## City of Mississauga Department Comments

Date Finalized: 2024-01-17 File(s): A35.24 Ward: 1

Property Address: 593 Ridgemount Cres

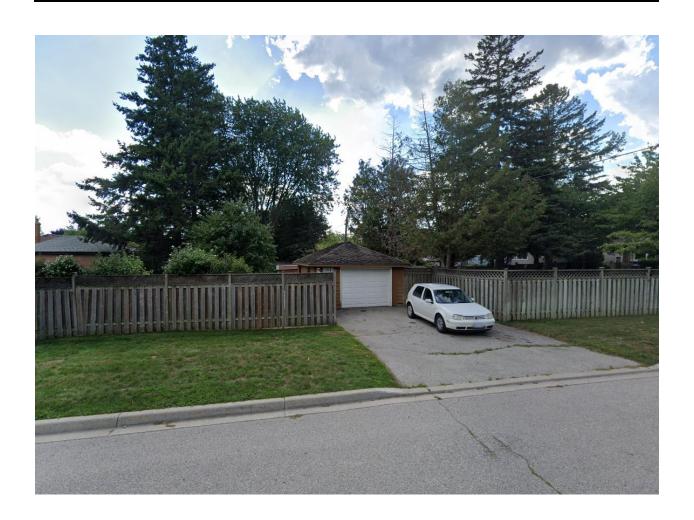
With regard to variance number 6, our Traffic Planning Section does not support a secondary access for the subject site. As per the TAC Geometric Design Guide for Canadian Roads, "Single family residential properties [are] normally restricted to one driveway, irrespective of frontage." Consistent with Traffic Engineering best practices, the number of accesses to the municipal road network are to be minimized to optimize roadway safety and efficiency, minimize vehicular and pedestrian conflict points, ensure sufficient space is available between driveways for signage/utilities/trees/other street appurtenances, maintain on-street parking spaces, clearly identify which property each driveway serves, etc. In addition, in this particular instance we cannot see the rationale for having a circular driveway on this property.
